Addendum 1
10-24-13
City of Sausalito

SAUSALITO CIVIC CENTER

PARKING LOT IMPROVEMENTS
SITE AND GRADING PLAN

C1.0

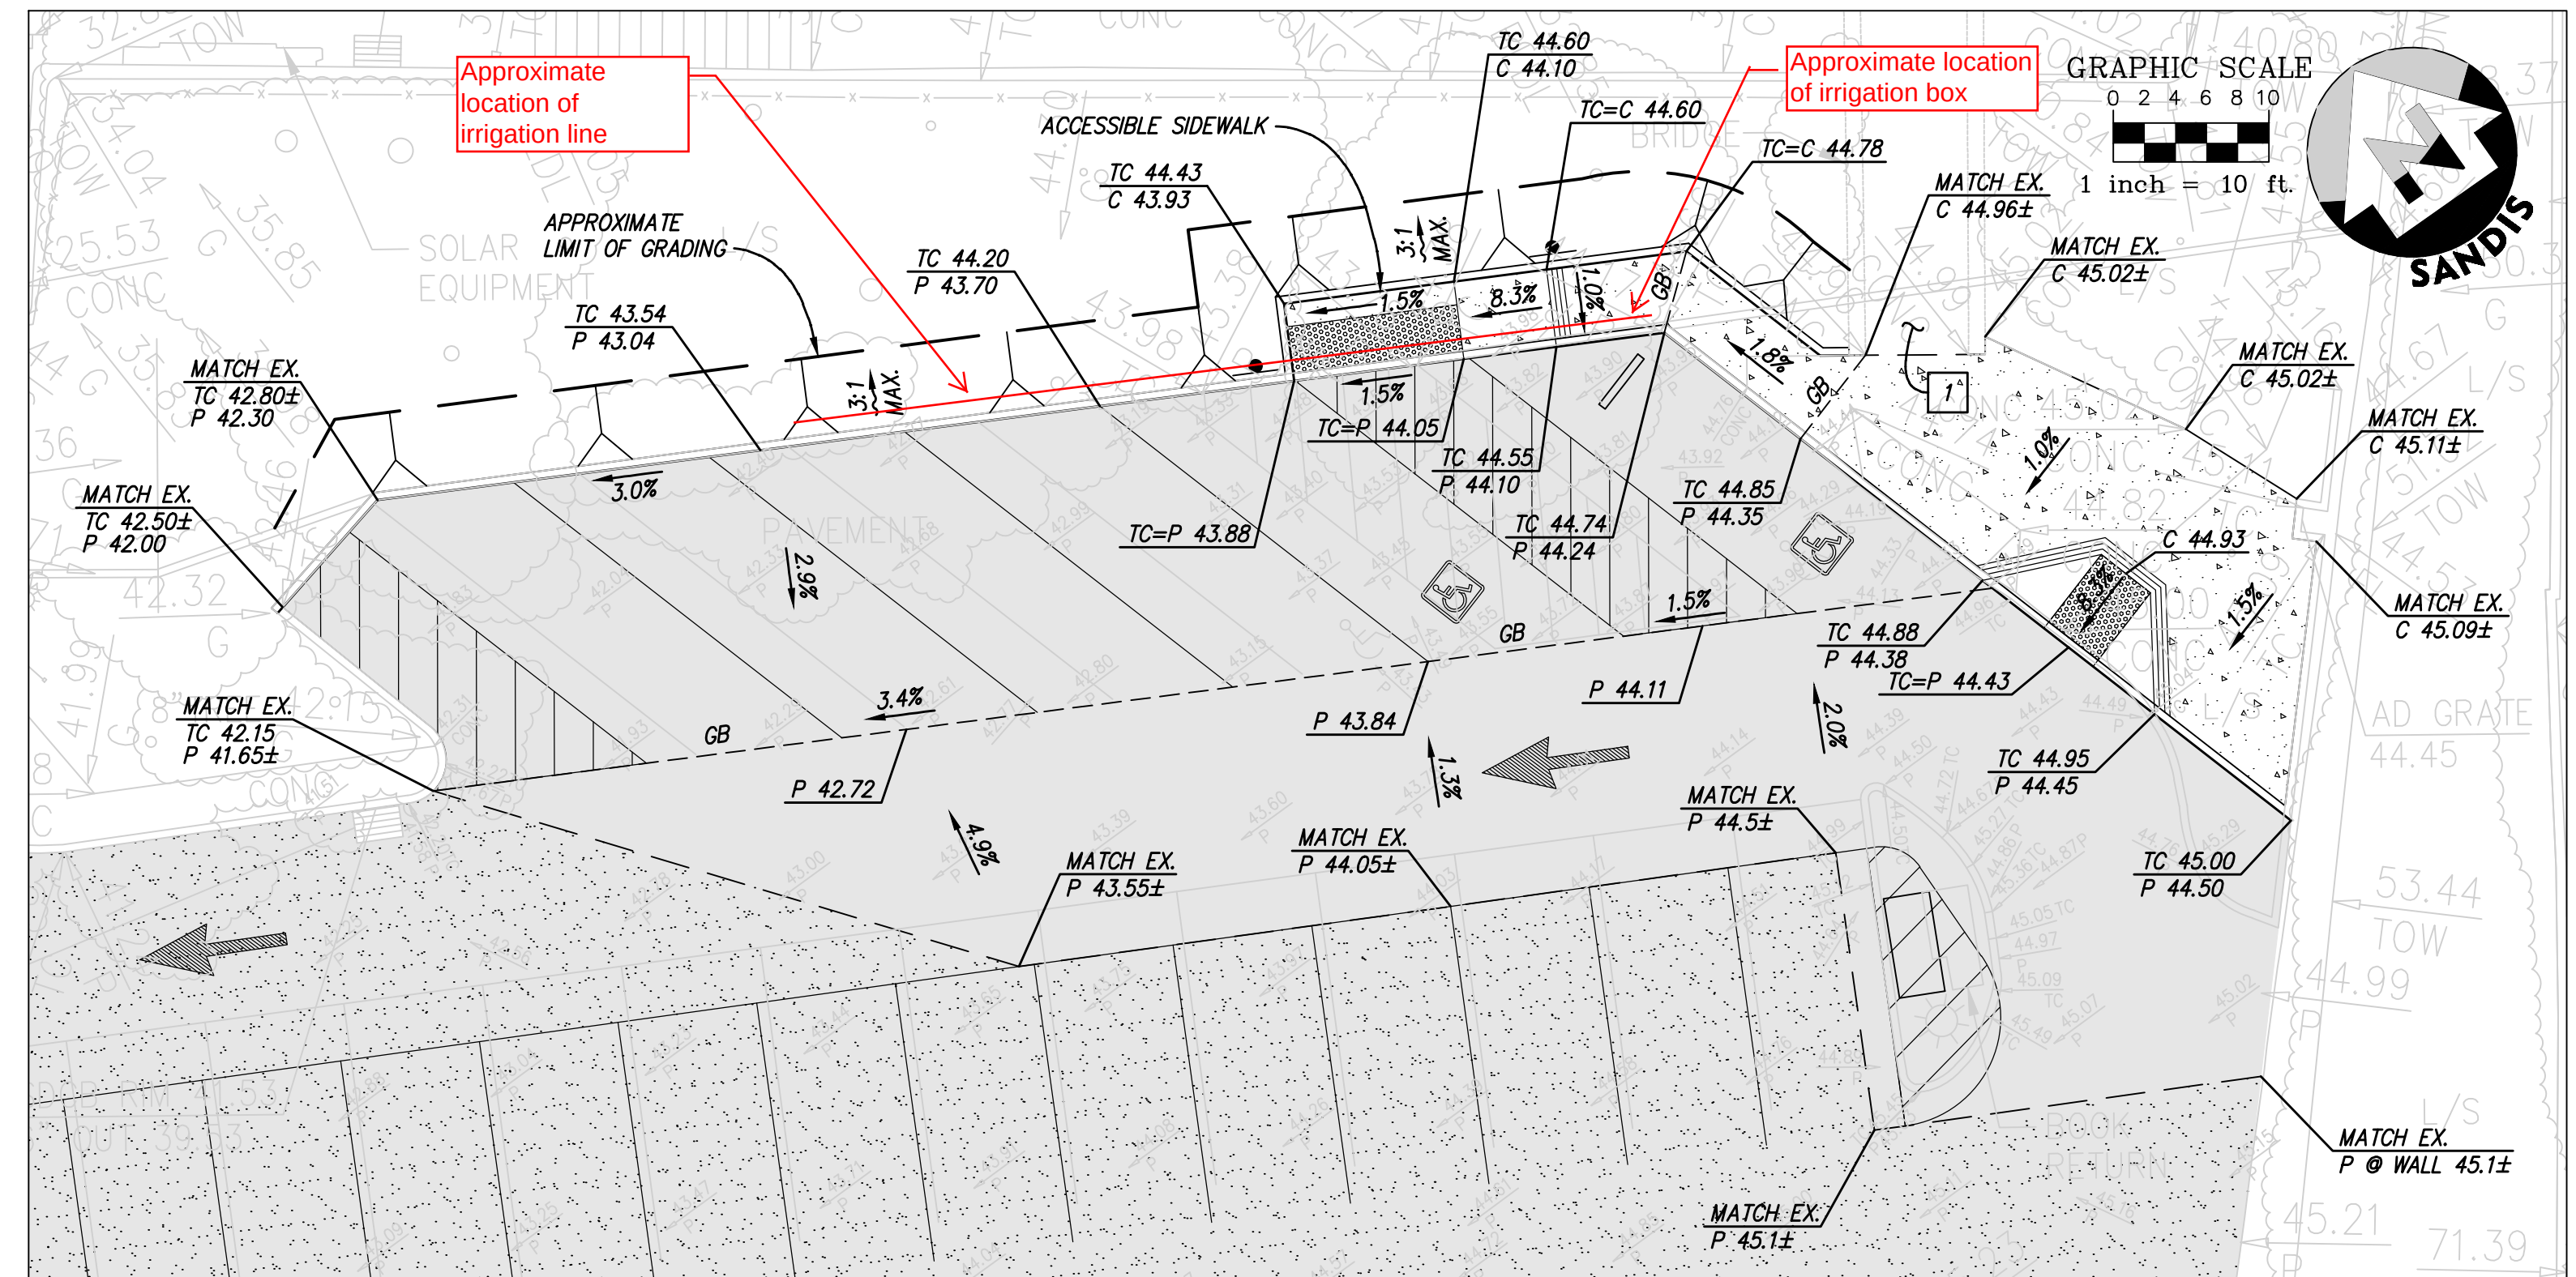
- ALL STRIPING SHOWN ON PLAN TO BE 4" WIDE WHITE THERMOPLASTIC UNLESS OTHERWISE SPECIFIED.
- ACCESSIBLE PARKING STALLS AND ACCESSIBLE PATH OF TRAVEL SHALL MEET CURRENT ACCESSIBILITY REQUIREMENTS.
Sidewalk on Bee St. shall meet current accessibility requirements within the area of work.
